HIGH POINT - GUN CLUB TO 61ST AVENUE EXTENSION INFRASTRUCTURE SITE PLAN

Date	Submission / Revision
12/13/24	COA FOR APPROVAL

Design Project No: 19.1043.C.22
Drawing Title: OVERALL SITE PLAN
Drawing No: 2

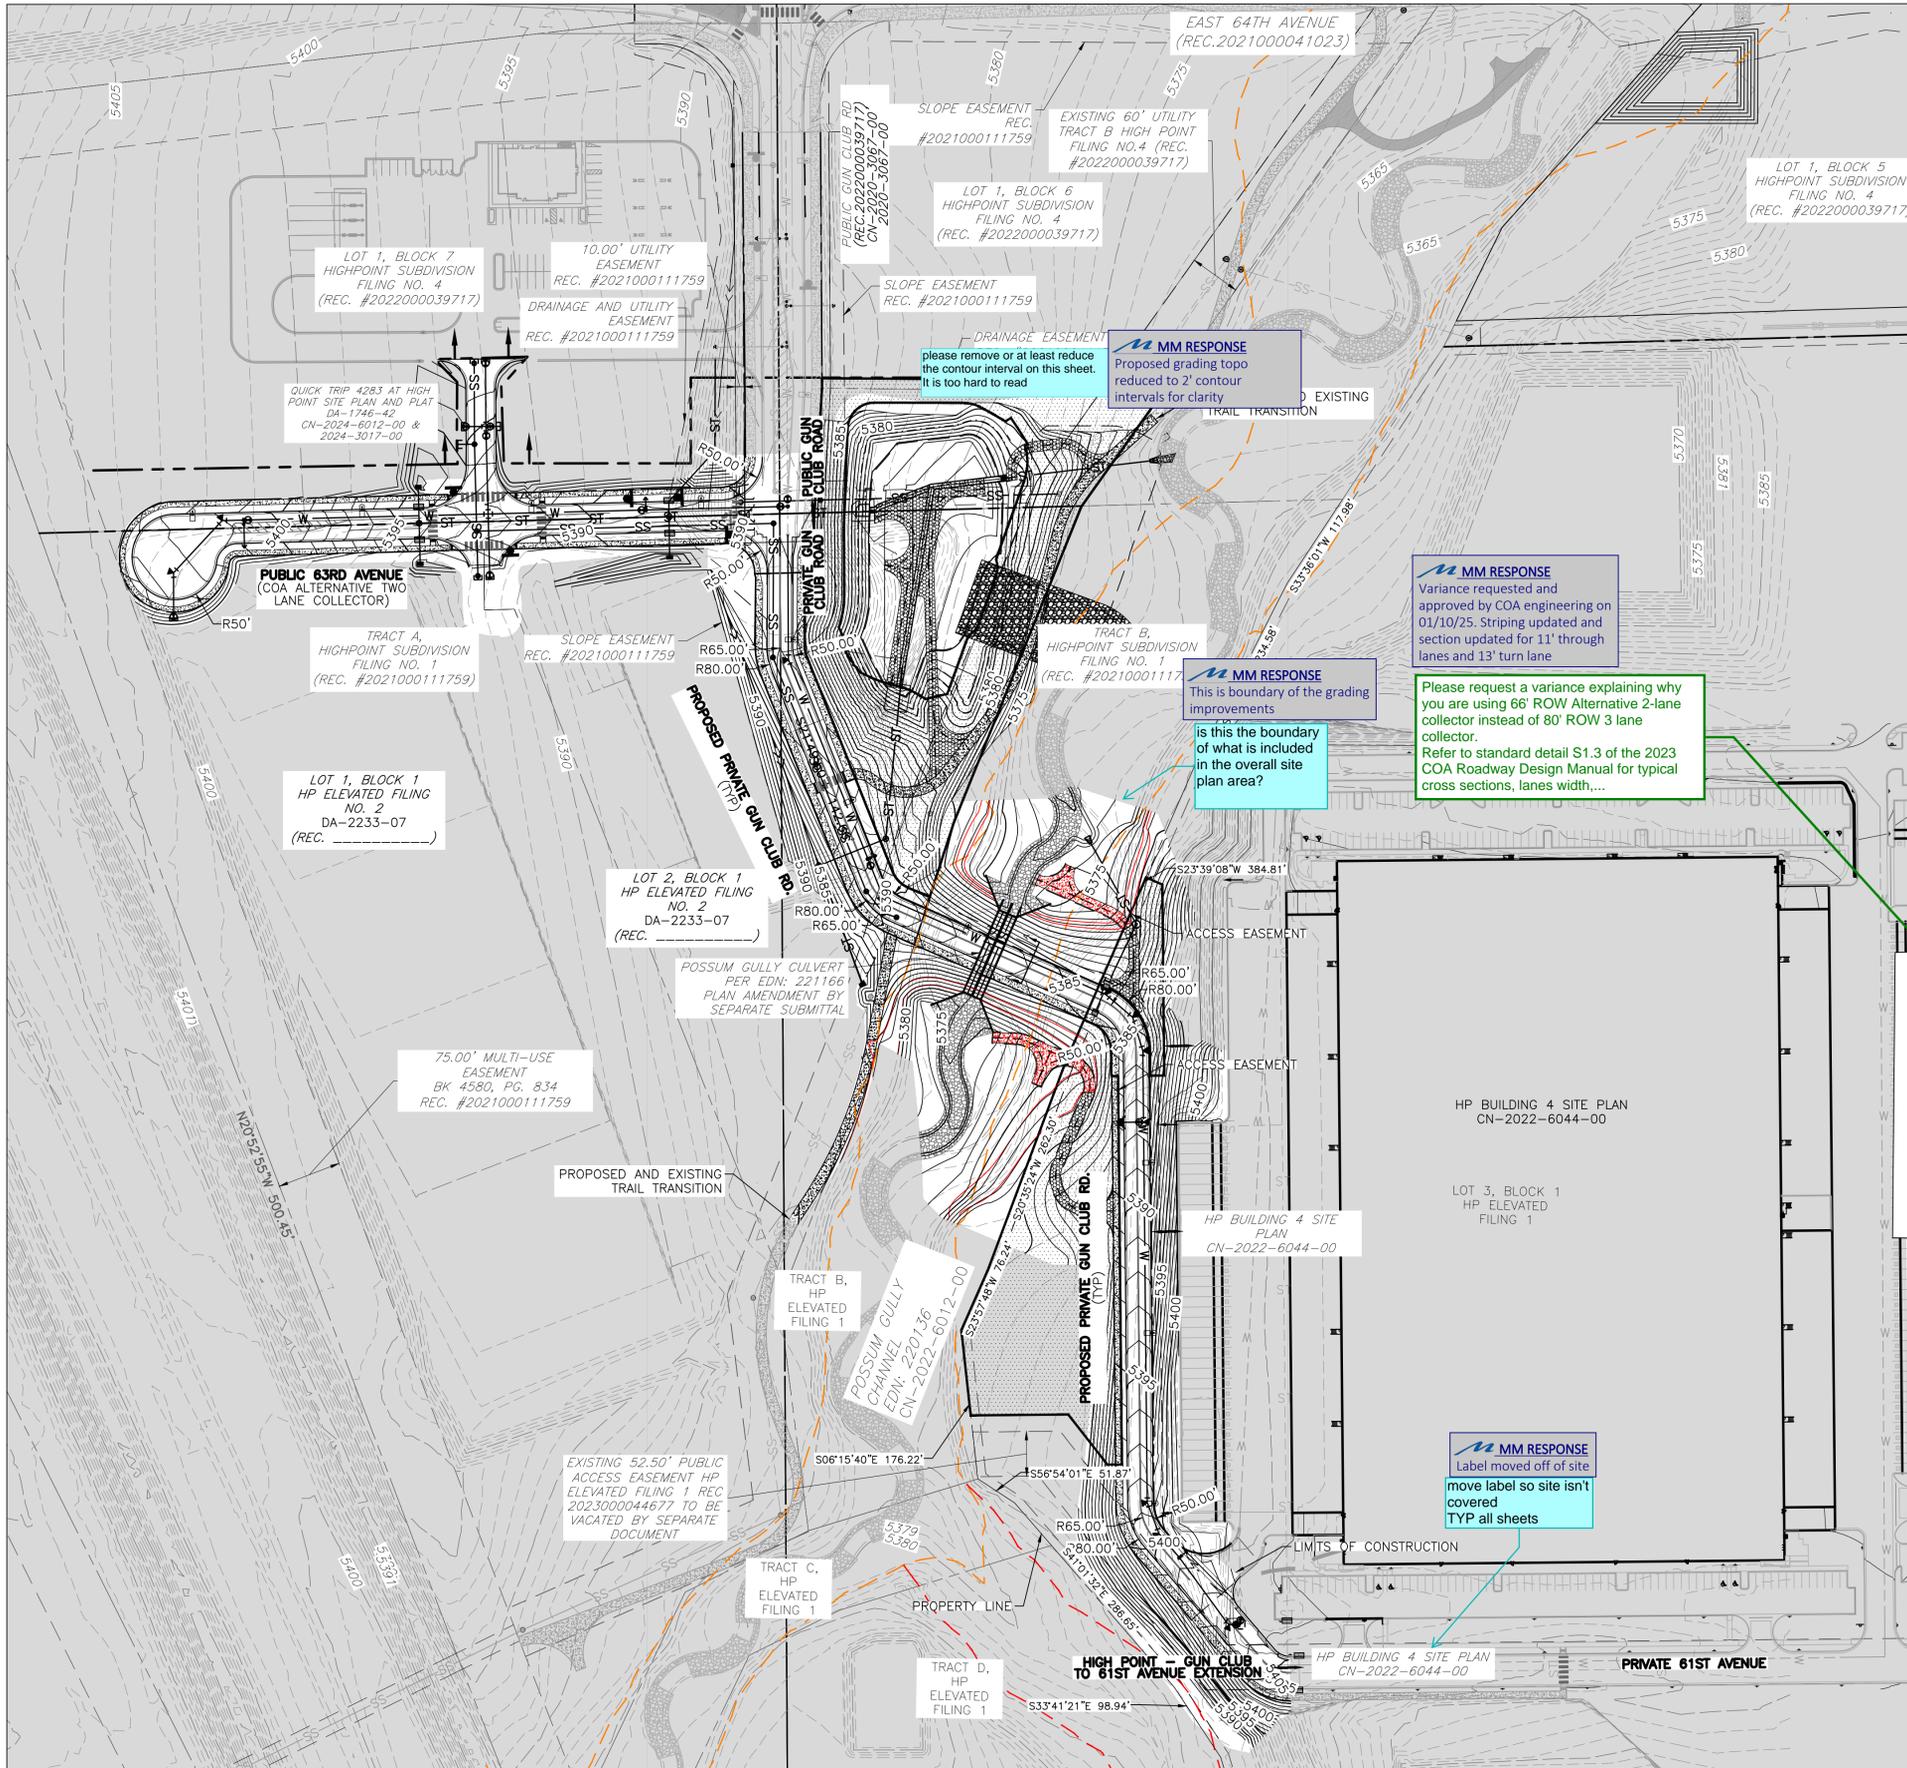
Please request a variance explaining why you are using 66' ROW Alternative 2-lane collector instead of 80' ROW 3 lane collector.
Refer to standard detail S1.3 of the 2023 COA Roadway Design Manual for typical cross sections, lanes width,....

MM RESPONSE
This is boundary of the grading improvements
is this the boundary of what is included in the overall site plan area?

MM RESPONSE
Label moved off of site
move label so site isn't covered
TYP all sheets

MM RESPONSE
Proposed grading topo reduced to 2' contour intervals for clarity

MM RESPONSE
Variance requested and approved by COA engineering on 01/10/25. Striping updated and section updated for 11' through lanes and 13' turn lane

Drawing No.
11

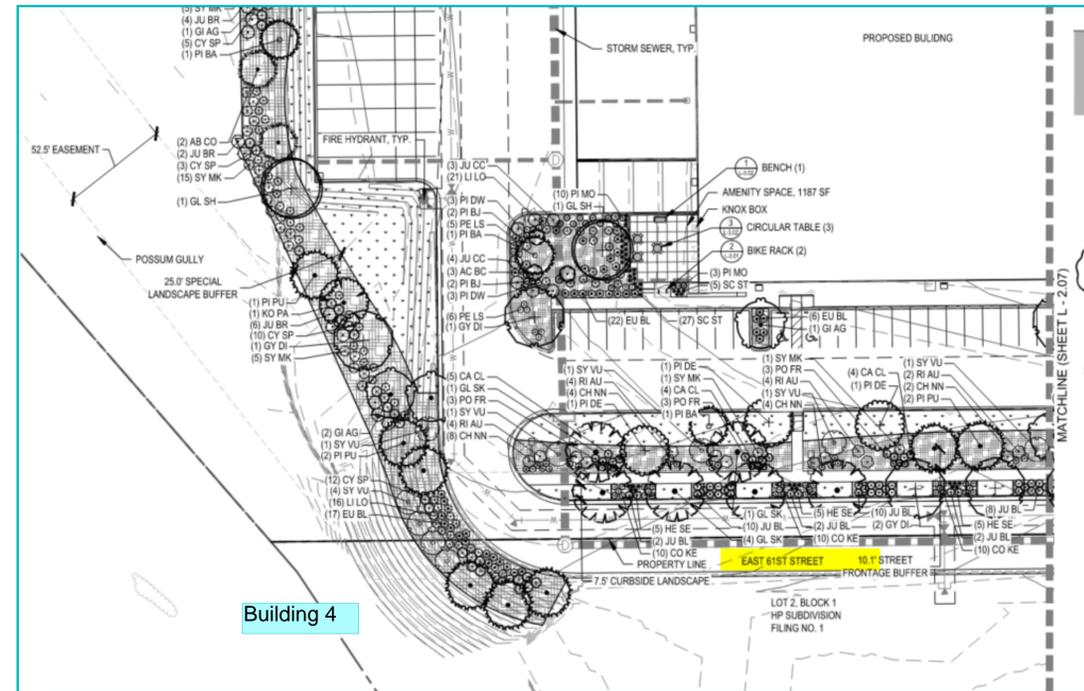
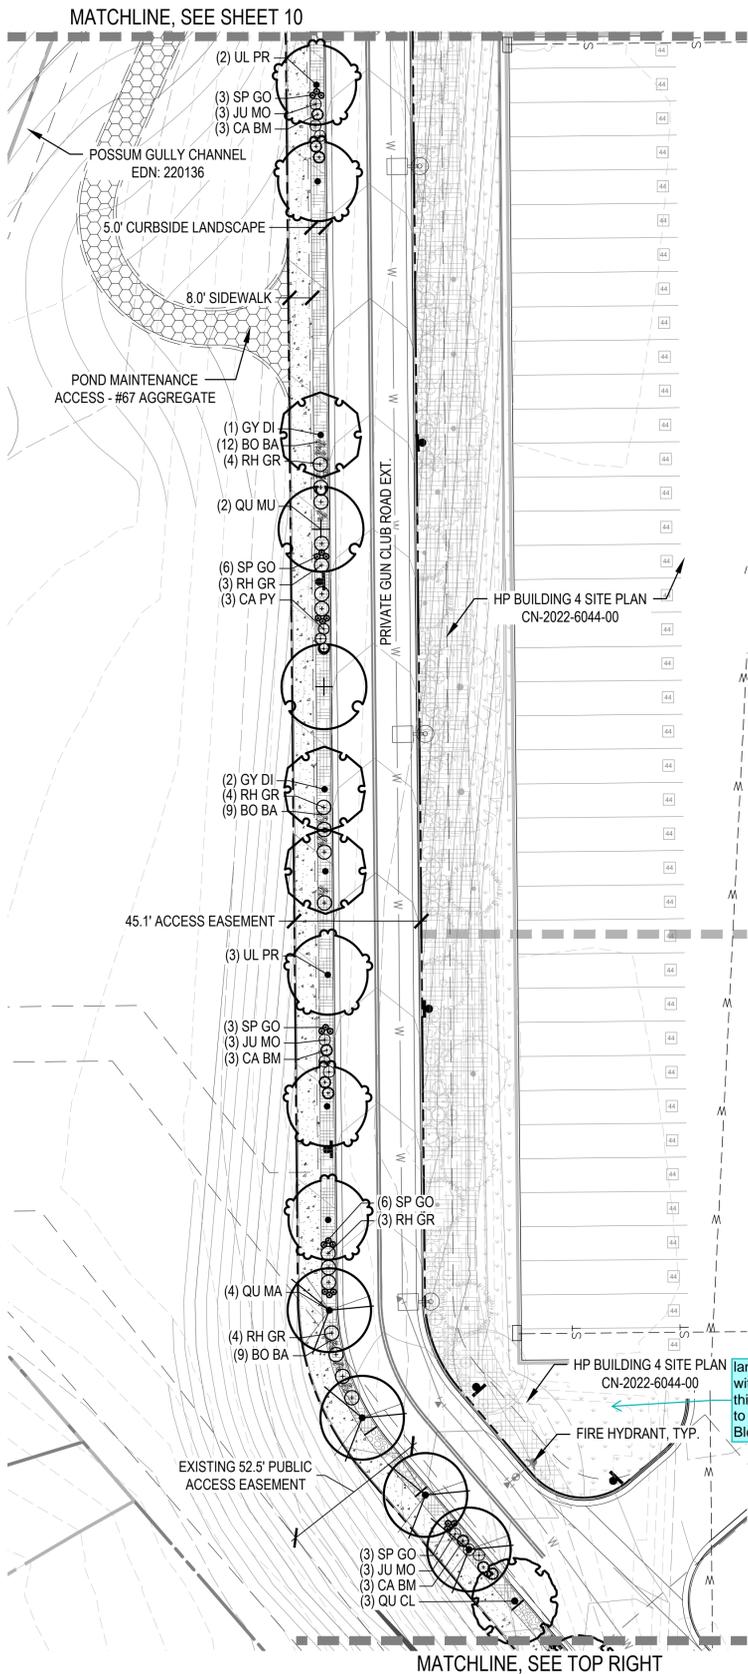
add note that the Building 4 site plan will be amended to revise the access and landscape plans

landscape required with this site plan for this area of it will have to be added to the Bldg 4 plans

gray out sidewalk. Add note that south half of 61st will be designed and constructed at the time of development of Lot, block.....

ND RESPONSE: Note added.

ND RESPONSE: Understood.

ND RESPONSE: Sidewalk grayed out, note added to match civil.
